# Access Compliance Report

## Public Rights-of-Way

### (Curb Ramps)

Intersection ID: 13056	Main Street: S_MINT_ST	Cross Street: W_BLAND_ST	Location: W
ADA ID: CB2138E04146	Ramp Type: PerpDiag	Initial Pass/Fail: Fail	Overall Compliance: No
			Severity Score: 21.25

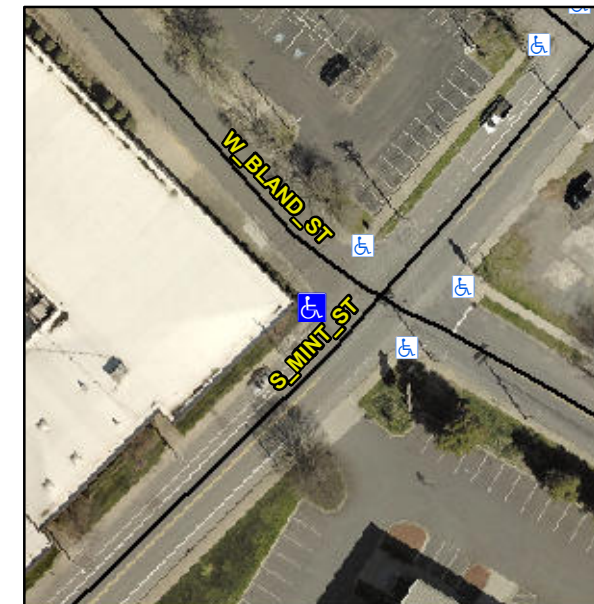
**R304.5.1, R304.2.2**

Compliance	Description	Data	Compliance	Description	Data
N/A	Ramp Length (in)	48.0	No	Ramp Slope (%)	8.8
No	Ramp Width (in)	37.0	Yes	Ramp XSlope (%)	1.5
N/A	Flare Type LT	N/A	N/A	Flare Type RT	N/A
N/A	Flare Slope LT (%)	N/A	N/A	Flare Slope RT (%)	N/A
N/A	Flare Traversable LT?	N/A	N/A	Flare Traversable RT?	N/A
N/A	Landing Length (in)	N/A	N/A	DWS Provided?	N/A
N/A	Landing Width (in)	N/A	N/A	DWS Contrast?	N/A
N/A	Landing Slope (%)	N/A	N/A	DWS Length (in)	N/A
N/A	Landing X Slope (%)	N/A	N/A	DWS Full Width?	N/A
N/A	Landing Curb? (Y/N)	N/A	N/A	DWS Offset (in)	N/A
N/A	Shared Landing?	N/A			
N/A	Gutter Ponding?	N/A	N/A	Gutter Slope (%)	N/A
N/A	Gutter Lip Ht (in)	N/A	N/A	Gutter X Slope (%)	N/A
N/A	Painted X Walk1?	No	N/A	Painted X Walk2?	No
	X Walk 1 Direction	To SE		X Walk 2 Direction	To NE
N/A	X Walk 1 Width (in)	N/A	N/A	X Walk 2 Width (in)	N/A
	X Walk 1 Slope (%)	3.8		X Walk 2 Slope (%)	1.5
	X Walk 1 X Slope (%)	0.1		X Walk 2 X Slope (%)	0.4

**Remove & Replace Curb Ramp With Two New Directional Ramps or Equivalent.**
